# Access Compliance Report

## Public Rights-of-Way

### (Curb Ramps)

Intersection ID: 10032503	Main Street: N_CALDWELL_ST	Cross Street: N/A	Location: E
ADA ID: 2F48C8F17565	Ramp Type: Perp	Initial Pass/Fail: Fail	Overall Compliance: No
Codes/Mitigation Info/Possible Solution		Field Measurements/Component Compliance	
Severity Score: 12.5

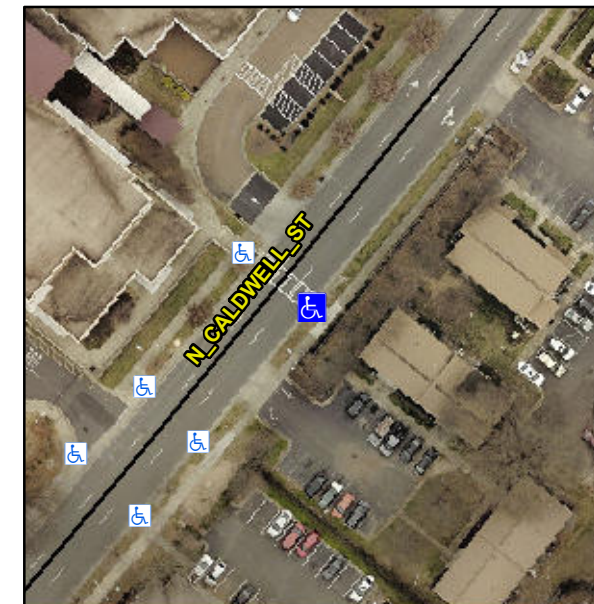
**Remove & Replace Entire Ramp.**

**Not Found, R304.2.2**

Compliance	Description	Data	Compliance	Description	Data
N/A	Ramp Length (in)	86.0	No	Ramp Slope (%)	8.9
Yes	Ramp Width (in)	60.5	Yes	Ramp XSlope (%)	0.7
N/A	Flare Type LT	N/A	N/A	Flare Type RT	N/A
N/A	Flare Slope LT (%)	N/A	N/A	Flare Slope RT (%)	N/A
N/A	Flare Traversable LT?	N/A	N/A	Flare Traversable RT?	N/A
N/A	Landing Length (in)	N/A	N/A	DWS Provided?	N/A
N/A	Landing Width (in)	N/A	N/A	DWS Contrast?	N/A
N/A	Landing Slope (%)	N/A	N/A	DWS Length (in)	N/A
N/A	Landing X Slope (%)	N/A	N/A	DWS Full Width?	N/A
N/A	Landing Curb? (Y/N)	N/A	N/A	DWS Offset (in)	N/A
N/A	Shared Landing?	N/A			
N/A	Gutter Ponding?	N/A	N/A	Gutter Slope (%)	N/A
N/A	Gutter Lip Ht (in)	N/A	N/A	Gutter X Slope (%)	N/A
N/A	Painted X Walk1?	Yes	N/A	Painted X Walk2?	N/A
	X Walk 1 Direction	To NW		X Walk 2 Direction	N/A
N/A	X Walk 1 Width (in)	112.0	N/A	X Walk 2 Width (in)	N/A
	X Walk 1 Slope (%)	3.6		X Walk 2 Slope (%)	N/A
	X Walk 1 X Slope (%)	1.2		X Walk 2 X Slope (%)	N/A
